Interactive comment on “Long term variability of the annual hydrological regime and sensitivity to temperature phase shifts in Saxony/Germany” by M. Renner and C. Bernhofer

M. Renner and C. Bernhofer

Received and published: 9 March 2011

Fig. 1. CUSUM graphs of time series of the annual phase of runoff ratio, the phase of basin temperature and interpolated basin average March snow depths for the basin Lichtenwalde.

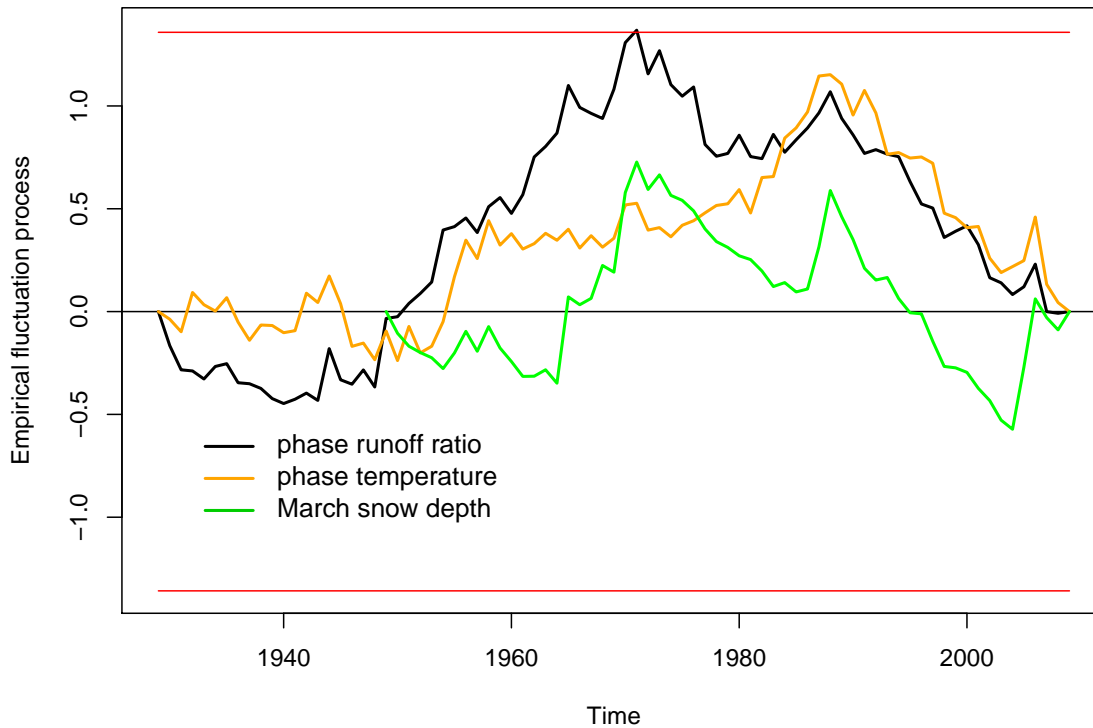
P830L4: I do not find that snow depth peaks in 1971, or if it does, then it does so even stronger a few years later. What happened here?

P833L1ff: I find this a too strong statement. In my view, the change point of 1971 is not apparent in the potential explaining variables.

Authors response:

For Fig. 11 we have chosen the March snow depth series from the station Fichtelberg. In this case it was thought to use raw station data, instead of interpolated basin average

data. The CUSUM plot shows enough similarity to the annual phase of runoff ratio, however, the referee is right, the small peak in 1971 is not exactly matching with the other. As already mentioned, there is also interpolated basin average snow depth data available. For clarity, we will add a CUSUM plot of the basin average snow depth for Lichtenwalde.

As can be seen from Fig. 1 (attached to this reply), there are two distinct peaks, concurrent with the one of runoff ratio. In this case there are 10 snow depth observation stations available within the basin boundary to support the basin average. Further, the selection of the station Fichtelberg, a mountain peak station, is likely to have a different climatological evolution, than a basin average, established for an area of 1500 km^2 .

Authors response: This argument accompanies the one from above. Therefore, we choose to replace the CUSUM graph of snow depth at Fichtelberg in Fig. 11, with the basin average March snow depths. Further this signal appears in other basins originating in the Upper Ore Mountains.

Fig. 2. Annual values and 11-year moving averages for the annual phase of runoff ratio and half-flow dates.

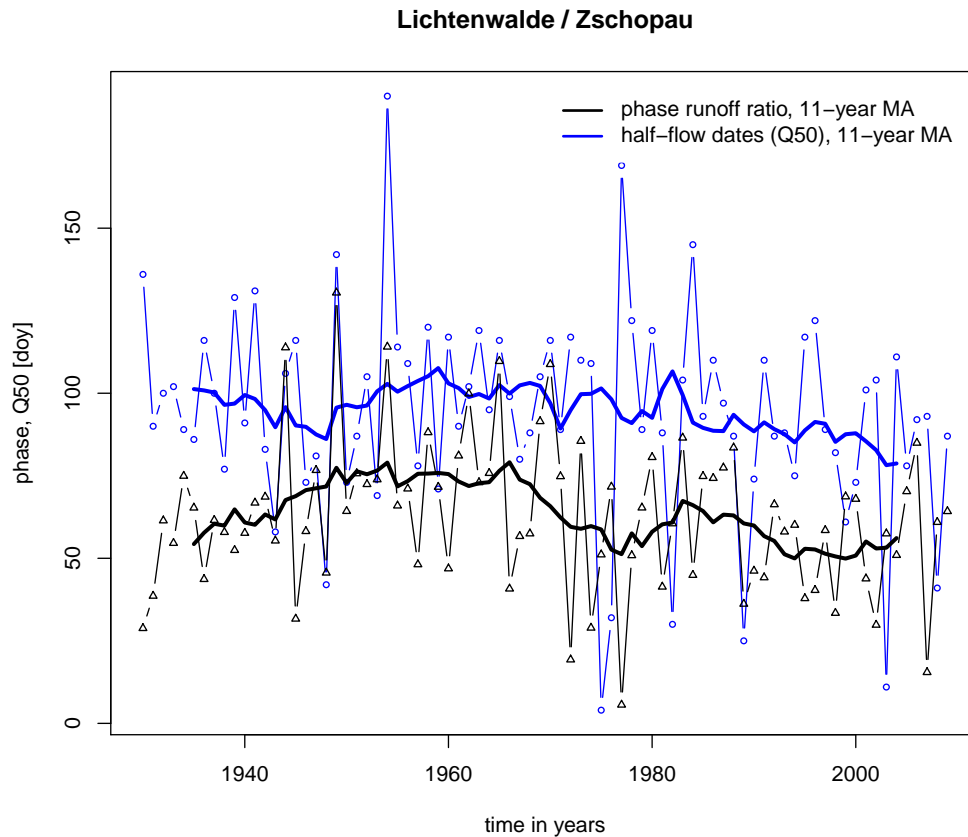
P831L14f: This statement is neither shown in the plots nor discussed.

Authors response: The statement was, that the low frequent variability of Q_{50} and ϕ_{RR} is similar. For illustration see the attached Fig. 2. It shows annual values and 11-year moving averages (MA) for both timing measures. It can be seen that both series have a tendency towards earlier timing over the whole period. Differences are induced by different calculation schemes and additional variability introduced by precipitation in the phase of runoff ratio.

With respect to the complementary usage of half-flow dates, it may be valuable to add such a graph to the analysis.
